Board of Zoning and Planning

Staff Report

February 22, 2024

1) Application Number: BZAP-24-3

Rendering of proposed porch and terrace

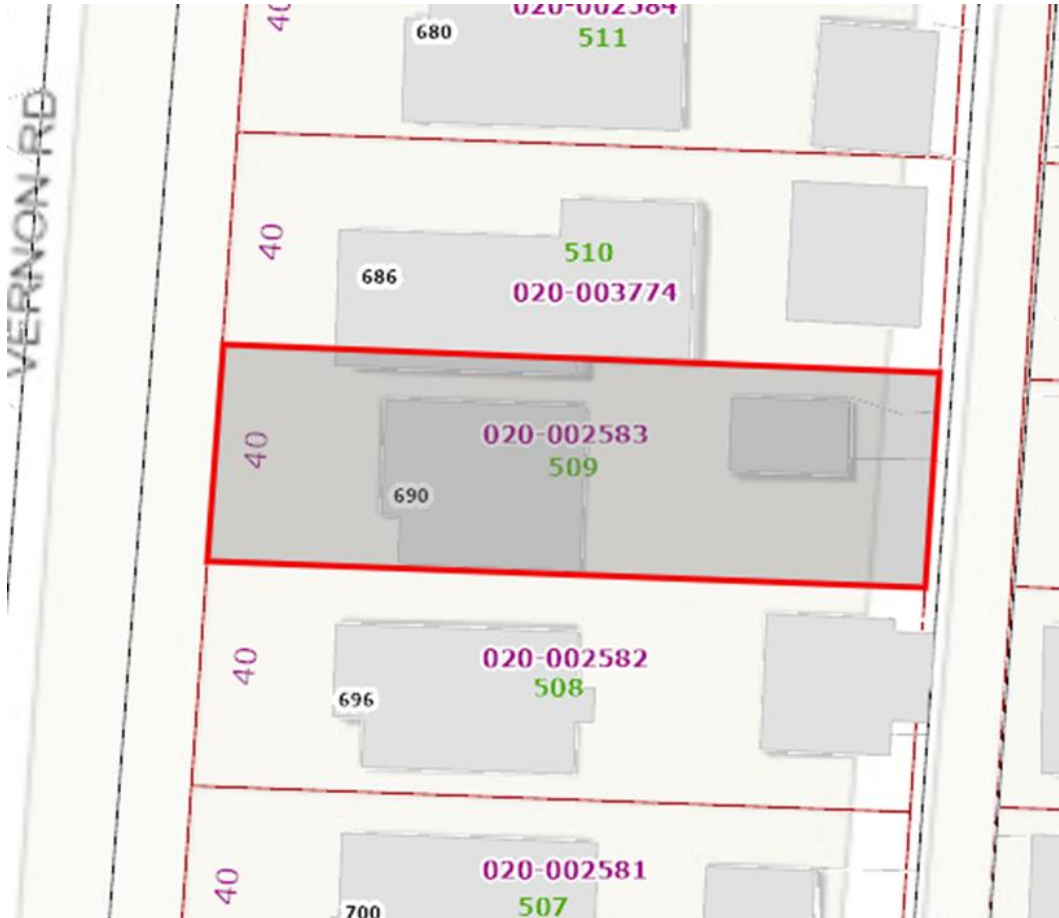
This application was before the ARB, who did not have a problem with the overall design but due to the lack of details, they provided a recommendation to proceed to BZAP with a remand back to ARB for final design review, should the variance be granted.

Staff had questions regarding the setback from the front property line of the existing principal structure. A mortgage survey found in the property file conflicted with the measurements taken in the field. We have since obtained a boundary survey and it rules out the need for a variance from the front property line. The code allows an open porch to encroach 10' into the front yard setback. The proposed open porch will encroach 6'.

Bexley code section 1252.09 further requires a 6.6' setback from the side property line. The existing principal structure is 6' from the side, so a 6" variance is what is being requested for the proposed front porch.

If the board finds it appropriate to allow for the expansion of the non-conforming garage in accordance with Bexley Code Section [1252.15\(g\)\(a\)](#), and for the addition of the open front porch to encroach 6" inches into the 6'6" required setback from the side property line in accordance with Bexley Code Section [1252.09](#), the Board should consider a Remand back to the Architectural Review Board for final review of the design details if they are not yet revealed – I will defer to Karen Bokor to address those details.
